Re: O3b Limited Response to Commission Questions
IBFS File No. SAT-AMD-20161115-00116 (Call Sign S2935)

O3b Limited (“O3b”) hereby provides the following supplemental information in response to the letter dated March 21, 2017,¹ regarding the above-referenced O3b application.² The text of the questions in the Commission Letter is provided below (with footnotes omitted), followed by O3b’s response for each question.

Annex 2 EPFD ↓ using ITU EPFD validation software and O3b internal software

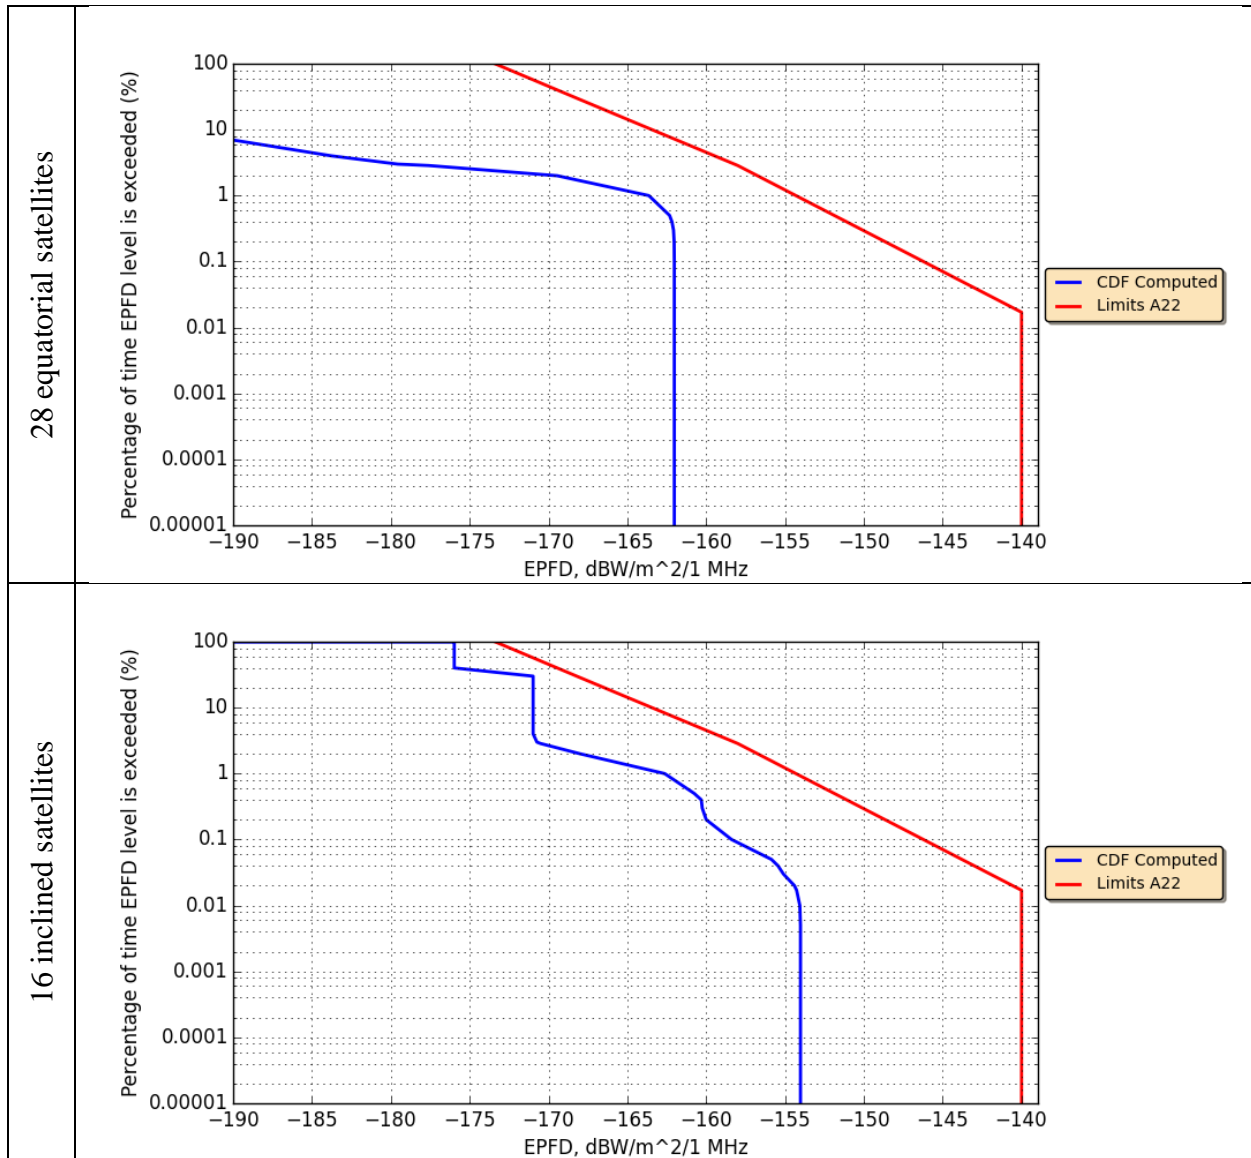
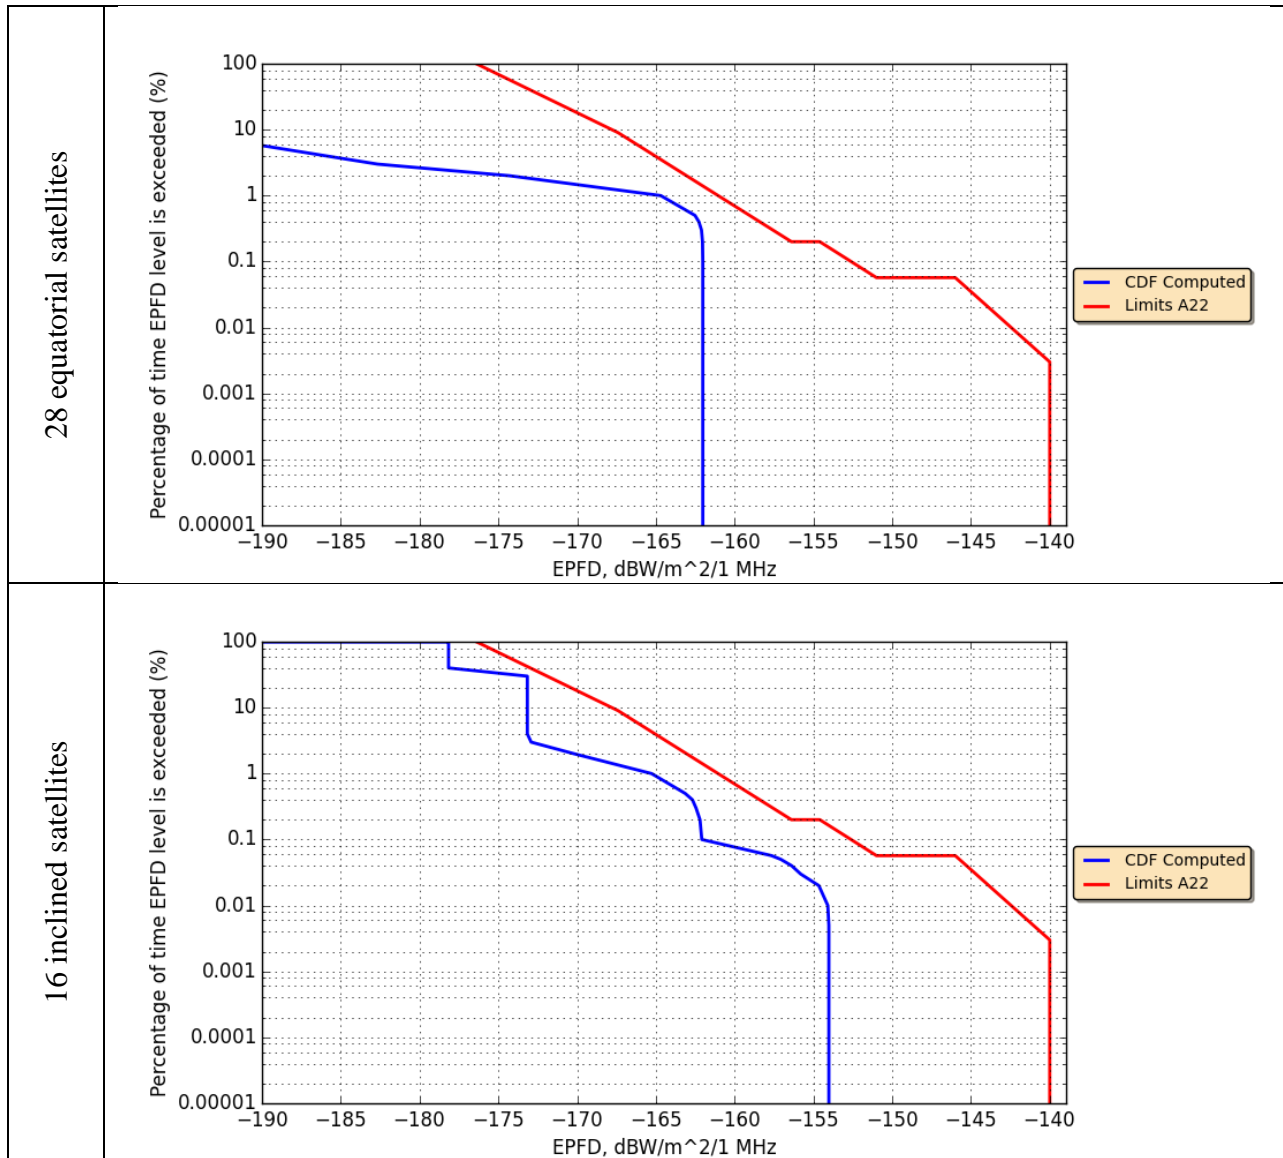
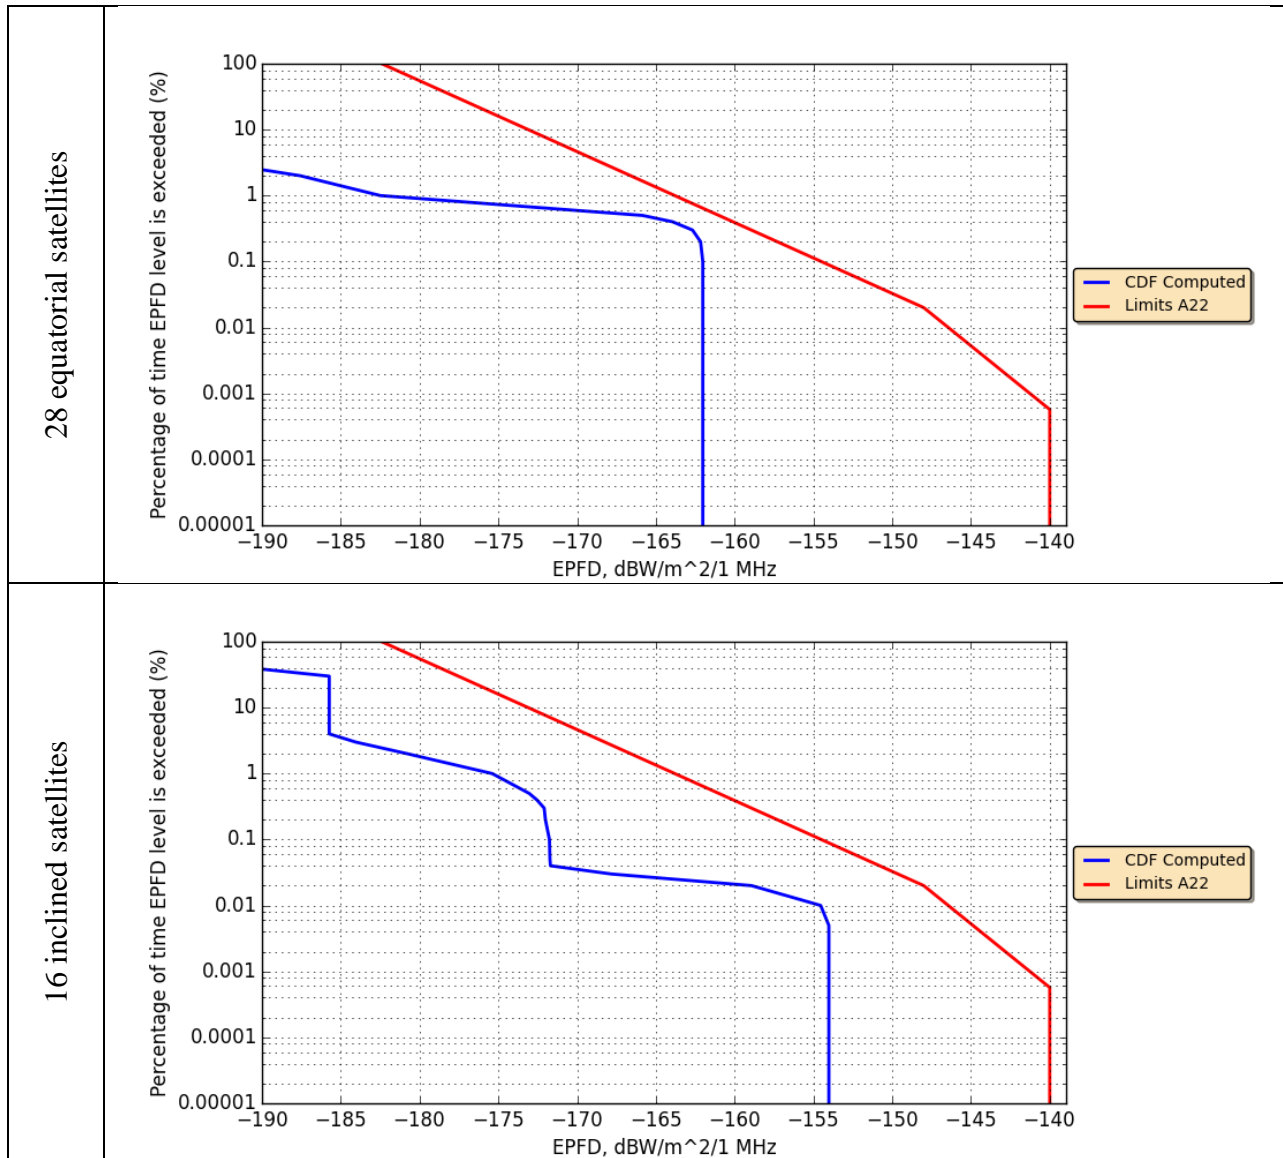
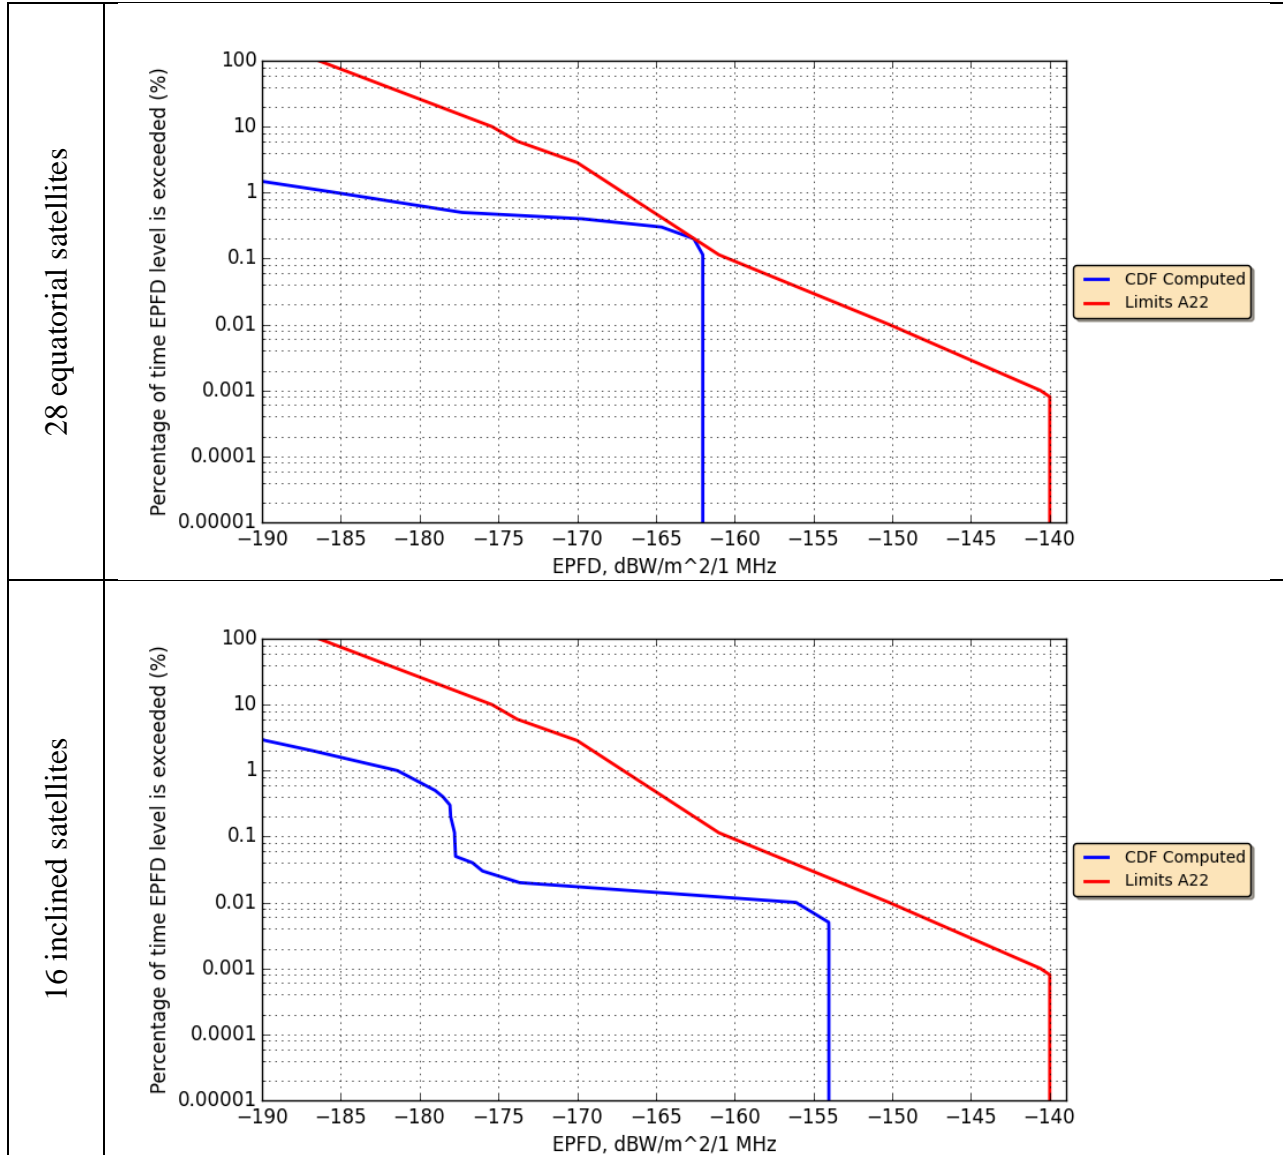
3. Article 22.5I of the ITU Radio Regulations requires NGSO networks to meet the equivalent power flux density (EPFD) limits specified in Articles 22.5C (EPFD ↓), 22.5D (EPFD ↑), and 22.5F (EPFD_{is}) for an NGSO system to fulfill its obligations with respect to geostationary satellite orbit (GSO) networks under Article 22.2. O3b provides, in its interference analysis, a narrative showing that it complies with Articles 22.5C (for the 17.8-18.6 GHz and 19.7-20.2 GHz frequency bands), 22.5D (for the 27.5-28.6 GHz and 29.5-30 GHz frequency bands) and Article 22.5F (for the 17.8-18.4 GHz frequency band). We request that O3b submit, for all these frequency bands, a complete set of PFD masks on the surface of the Earth for each of the 56 active space stations in its NGSO FSS system, and a complete set of NGSO FSS earth station EIRP masks as a function of the off-axis angle generated by the NGSO FSS earth station, which are required to run the ITU-R Recommendation S.1503 EPFD Validation Software. Please also supplement the amendment to include the output data files from the ITU EPFD Validation Software, and/or corresponding plots of the computed EPFD levels for the 56 active satellite constellation compared to the EPFD masks for each of the reference GSO and/or BSS earth station antennas.

The set of plots below show the EPFD ↓ results for the 19.7-20.2 GHz frequencies using the O3b proprietary software. The results are shown for each reference antenna size from Article 22 for these frequencies. The O3b software operates very similarly to the ITU validation software except for the inclusion of a parameter called minimum duration time, which allows for the modeling of steerable beams. This parameter is being discussed at the ITU Working Party 4A meeting as one of the enhancements to allow the software to model satellites whose beams track, or remain oriented toward, a fixed point on the Earth during the pass of the satellite. The O3b satellite beams will operate in this manner by pointing toward and tracking an earth station as the satellite passes overhead. The plots below show that the equatorial and inclined constellations meet the Article 22 single entry EPFD ↓ limits in these frequency bands for all antenna sizes using the proprietary O3b software.

Figure 3-1: GSO and O3b earth station antenna gain towards the horizon

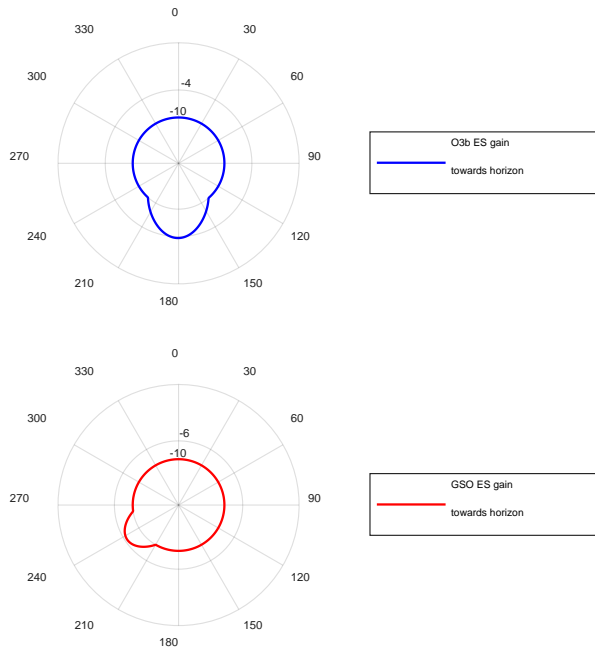
4. We note that O3b Limited requests authority to provide NGSO FSS service to the U.S. market using the 17.7-17.8 GHz frequency band. This band is not designated for NGSO FSS use, its use is limited to feeder links in the broadcasting-satellite service (BSS), in accordance with Footnote US271. As a result, there are no rules in place regarding sharing between NGSO FSS and BSS feeder links in this band, and the International Telecommunications Union (ITU) also has no EPFD limits in place for sharing between these two services. Consequently, O3b Limited must provide an appropriate technical analysis to justify its waiver request to use the band and to demonstrate how its use of this band will not cause interference to BSS feeder links.

O3b is seeking U.S. market access for NGSO operations in the 17.7-17.8 GHz frequencies. Annex 3 demonstrates the compatibility between: (1) the NGSO FSS satellite transmissions into BSS space station receivers; and (2) BSS feeder link transmitting earth stations into NGSO FSS receiving earth stations. The analysis demonstrates that the NGSO FSS satellite transmissions into the BSS space station receivers will not exceed the limits that are in place to protect Region 1 BSS space stations operating in the adjacent 17.8-18.4 GHz frequencies. In addition, Annex 3 shows that a separation distance ranging from a few hundred meters to approximately 7.5 km will allow the NGSO FSS earth stations to operate successfully notwithstanding the co-frequency operations of BSS feeder link transmitting earth stations. O3b is not seeking protection for these NGSO FSS earth stations from BSS feeder link earth stations. This technical showing is purely for completeness.

For Case 2, O3b has experience with this type of interference in Region 1. In one specific scenario, O3b worked closely with the teleport operator and the BSS feeder link earth station operator to resolve interference occurring between our collocated earth stations. O3b is not seeking protection from BSS feeder link earth stations, but based on its experience in Region 1, O3b believes that its earth stations can successfully operate in Region 2 notwithstanding predicted interference from BSS feeder link earth stations in the United States. The analysis below shows the worst-case interference between a transmitting BSS feeder link earth station and a receiving O3b earth station. Worst case is assumed to be when the O3b earth station is pointing directly towards the BSS feeder link earth station as shown in Figure 3.1.
